SITE: Centredale

Subject: **Centredale Manor Restoration Project Superfund Site:
Administrative Settlement Agreement and Order on Consent,
CERCLA Docket No. 01-2010-0045 (Effective June 30, 2010)**

This submission contains Emhart's revisions to the proposed Amended Sampling and Analysis Plan (SAP) that was included in our letter of November 4, 2010, to address EPA's comments. As we previously have discussed, the purpose for amending the SAP is to enable Emhart to collect sediment samples from the southern portion of the Oxbow area, and also to collect additional surface soil samples to assist U.S. EPA's further delineation of the Oxbow area.

FIRST AMENDMENT TO
ADMINISTRATIVE SETTLEMENT
AGREEMENT AND ORDER ON
CONSENT

Figure 1.
 Proposed Supplemental Oxbow Area Sediment and
 Surface Soil Sampling Locations November 4, 2010
 Proposed Amendment to Integral's July 21, 2010
 Sampling and Analysis Plan

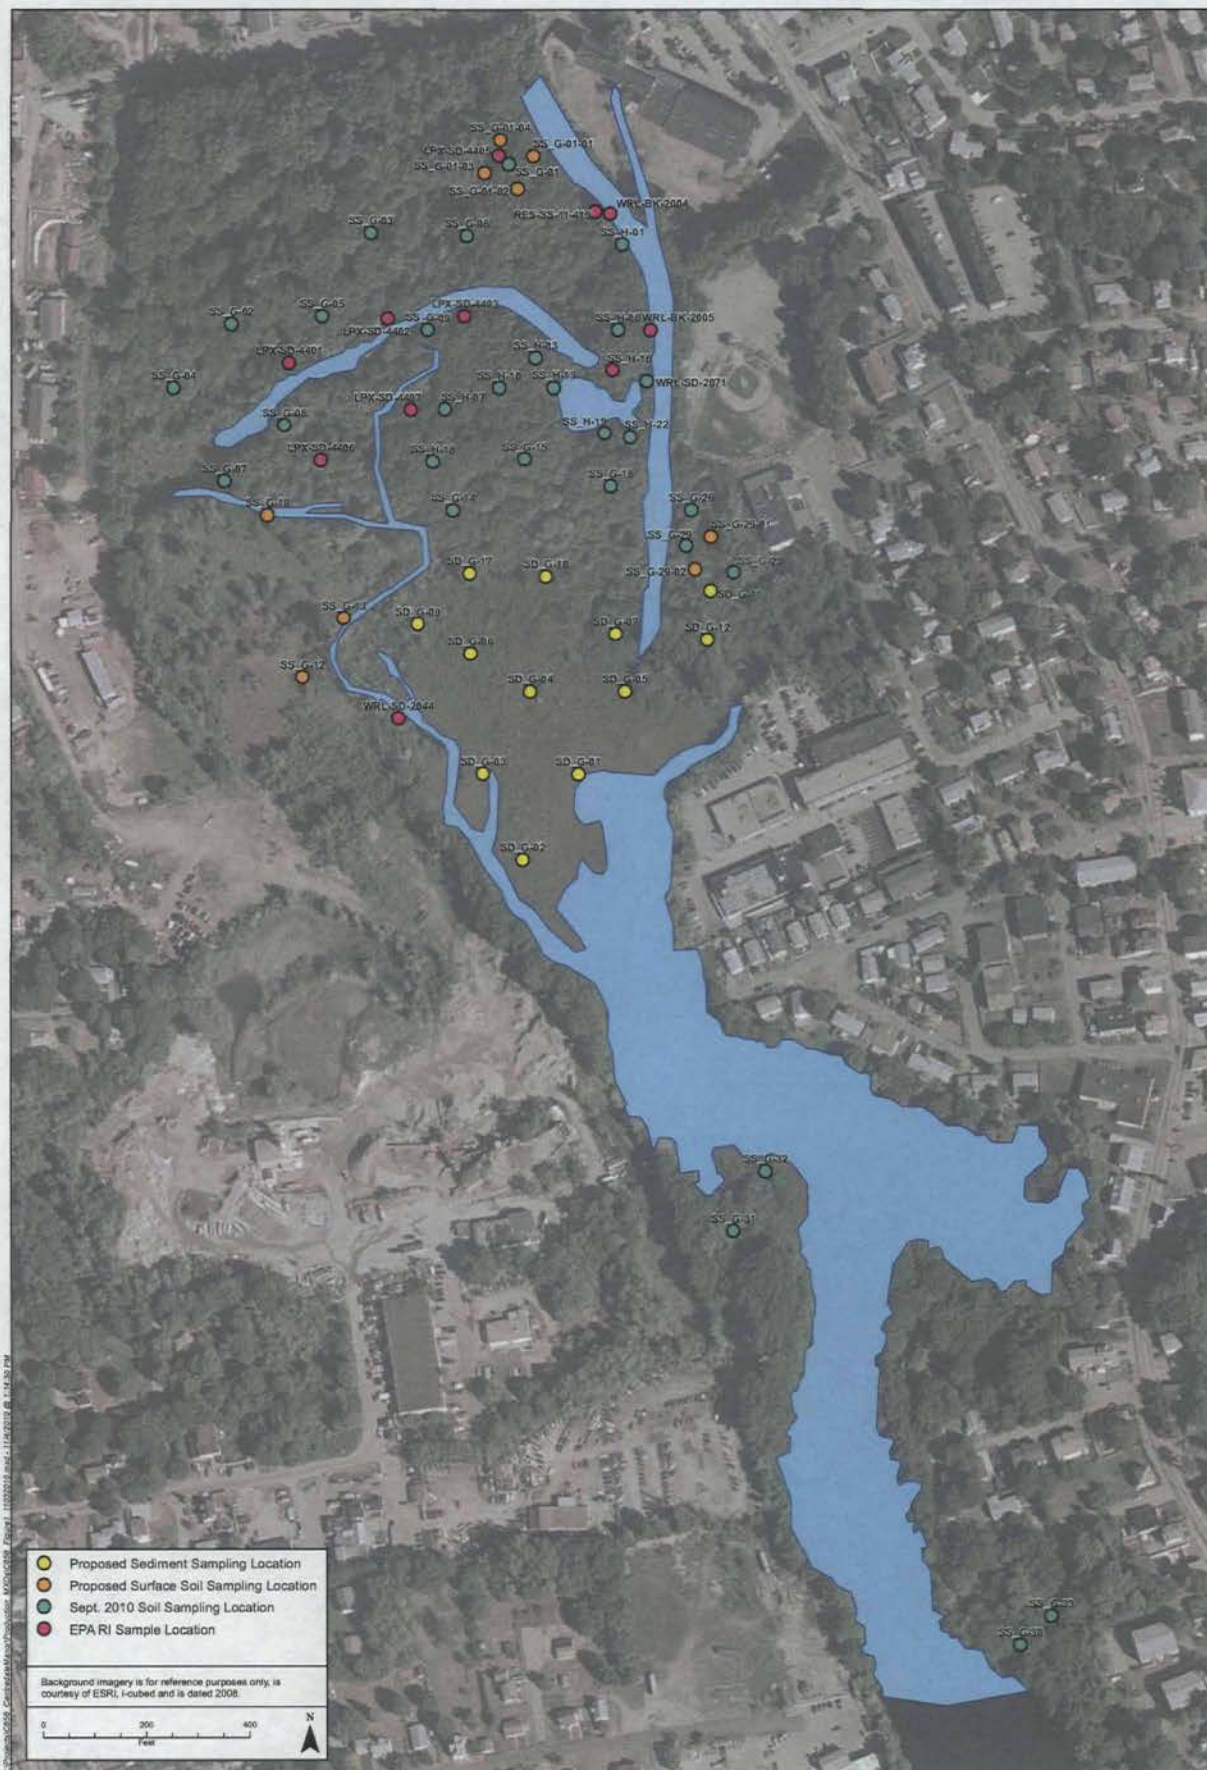
Emhart proposes to collect sediment samples at the locations identified as SD_G-XX (yellow dots) on the enclosed map. With the exception of SD_G-01, SD_G-11, and SD_G-12, these locations initially were identified in the SAP as proposed locations for collecting soil samples SS_G-16, SS_G-17, SS_G-19 through SS_G-25, and SS_G-28. However, as discussed, these proposed soil sampling locations were not sampled during the September 2010 field event because they were discovered not to contain vadose zone soil.

Emhart also proposes to sample sediment at SD_G-01. This sampling location was added to better define the extent of potential contamination in the southeastern-most part of the emergent palustrine wetland. Moreover, samples proposed to be taken at SD_G-11 and SD_G-12 are the locations of SS_G-23 and SS_G-26 in the SAP. As you may recall, SS_G-23 and SS_G-26 were relocated during the September 2010 field event to locations that were indicative of floodplain soils (i.e., vadose zone soil samples). Consequently, these two locations proposed for sediment sampling have not yet been sampled.

At each of the proposed sediment sampling locations shown on the enclosed figure, Emhart proposes to sample the 0-12 inch, 12-24 inch, and 24-36 inch depth intervals. Emhart will use dedicated, pre-cleaned sample core liners to collect the full 36 inch core, to the extent possible. The full core will be retrieved, water decanted or drawn off the surface of the sample with suction, and the sample extruded and segregated to yield samples indicative of the aforementioned sampling intervals. Once segregated into the appropriate sampling intervals, the sediment from each interval will be homogenized in a stainless steel bowl. For the 0-12 inch and 12-24 inch sampling intervals, samples will be collected for the list of analytes identified in the SAP (i.e., dioxins/furans, PCBs/pesticides, SVOCs, metals, grain size, and TOC). Samples will be logged, packaged and shipped to the laboratories identified in the SAP, Vista and CAS. For the 24-36 inch interval, sediment will be collected for dioxins/furans, but this sample will be place on "hold" in the laboratory. The determination of whether the 24-36 inch sample is analyzed will be made upon receipt and review of the data from the 0-12 and 12-24 inch intervals.

Emhart proposes to sample surface soil (0-12 inches) at four locations surrounding SS_G-01, as shown on the enclosed Figure 1. These samples will provide data to help further delineate the presence of dioxin surrounding this location. Based on the unvalidated results, sample SS_G-01 was found to contain 11.5 ppb of 2,3,7,8-TCDD, whereas EPA sample LPX-SD-4405, which is collocated with SS_G-01, was found to contain 4.4 ppb of 2,3,7,8-TCDD. The locations shown around SS_G-01 (SS_G-01-01 through SS_G-01-04) are 50 feet from the location of SS_G-01. Additionally, a vertical profile sample is proposed at the location of SS_G-01. This vertical profile sample will be collected from a depth of 1-2 feet and will be analyzed for dioxins/furans, PCBs/Pesticides, SVOCs, metals, TOC and grain size as per the SAP. Furthermore, Emhart proposes to collect two surface soil samples (0-12 inches) surrounding sample SS_G-29, located behind the former North Providence Boys and

Girls Club. The unvalidated result for 2,3,7,8-TCDD at SS_G-29 is 5.1 ppb. The two proposed soil sampling locations shown on the enclosed figure (SS_G-29-01 and SS_G-29-02) are 50 feet south and east of SS_G-29. Data from these samples will aid in delineating the concentrations of 2,3,7,8-TCDD in surface soil around SS_G-29. Data from the surface soil sample, SS_G-26, located approximately 50 feet north of SS_G-29, show a TEQ of 0.5 ppb. The subsurface soil sample at SS_G-26 contained 0.0149 ppb TEQ, indicating that dioxins are limited to the upper strata. Furthermore, groundwater was encountered at SS_G-26 at approximately 16 inches below ground surface so the vadose zone in this area is very limited in depth. Consequently, we are not currently proposing any additional vertical sampling in the vicinity of SS_G-29.

Finally, although not sampled in the September 2010 field effort because they are located in an area discovered to contain obvious fill material, Emhart now proposes to collect surface soil samples from SS_G-10, SS_G-12, and SS_G-13. Data from these samples will provide information concerning the western boundary of the Oxbow wetland area, which may be helpful in understanding the extent of contamination in this direction. These samples will be collected from the top 0-12 inches of soil.
